**SYSTEM/MODEL:** LEF

**MODIFICATION:** Increase LED timing circuit

# MODIFICATION INSTRUCTIONS

## INCREASE LED TIMING CIRCUIT LEF Master Stations

PC-1180 Component side view

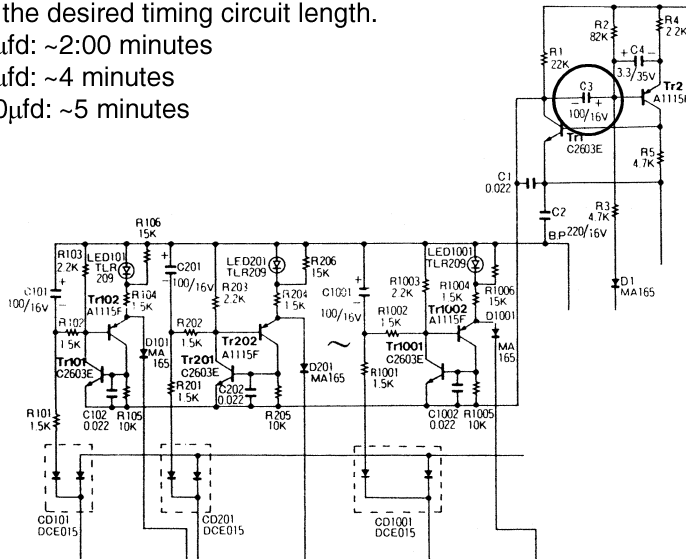
Replace C3

Locate and replace capacitor C3.  
Change value to a higher level to reach the desired timing circuit length.

- \* 220 $\mu$ fd: ~2:00 minutes
- \* 470 $\mu$ fd: ~4 minutes
- \* 1000 $\mu$ fd: ~5 minutes

PC-1288 Component side

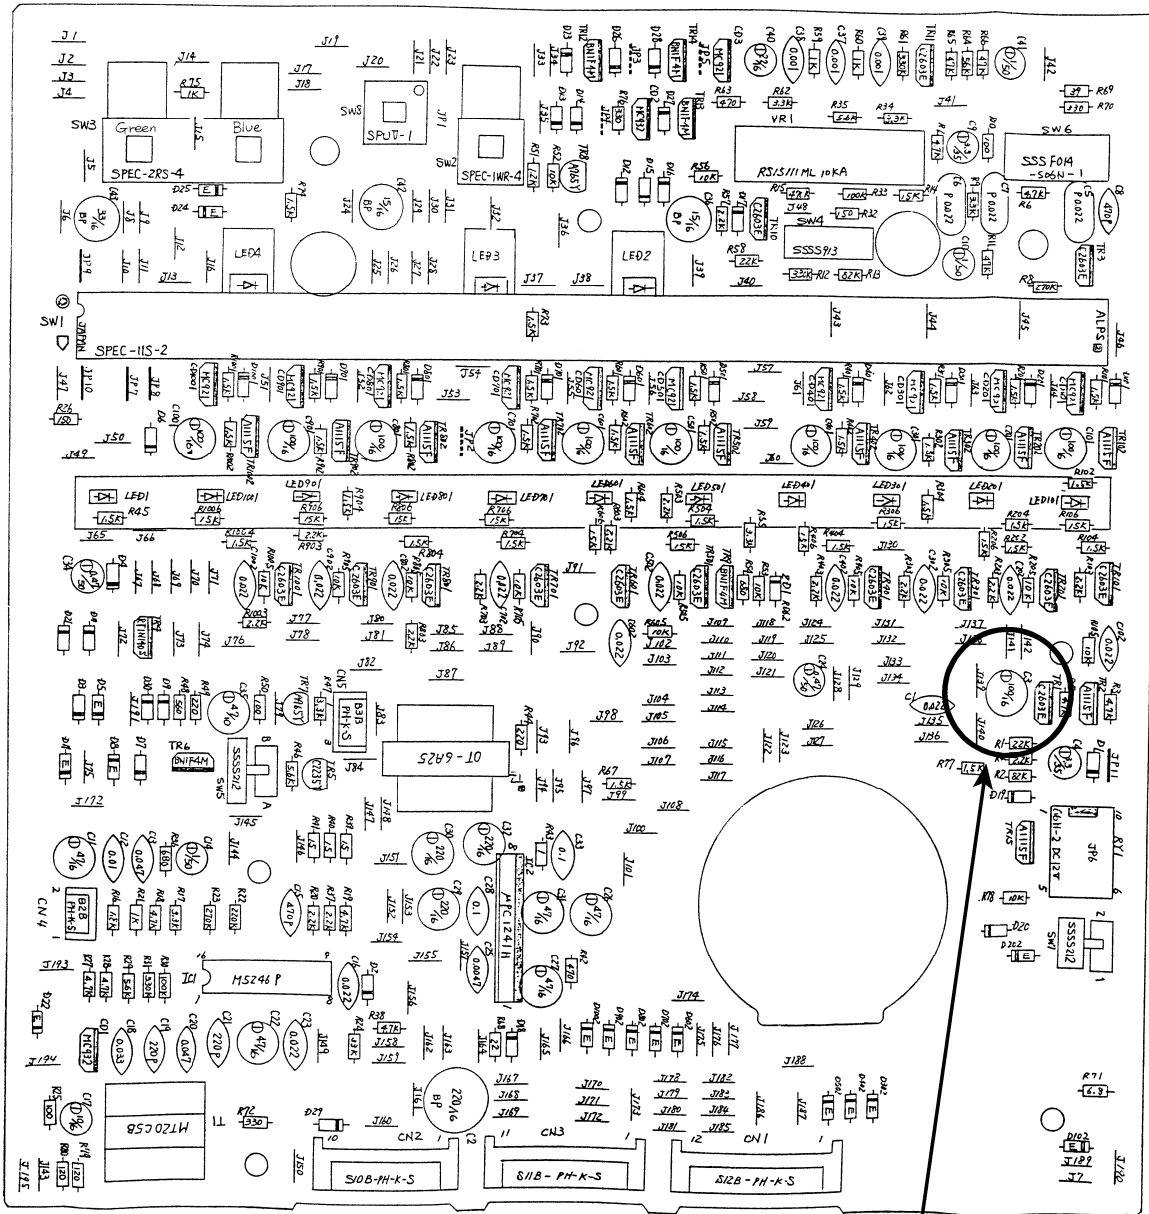
Locate and replace capacitor C3.  
Change value to a higher level to  
reach the desired timing circuit length.

Replace C3
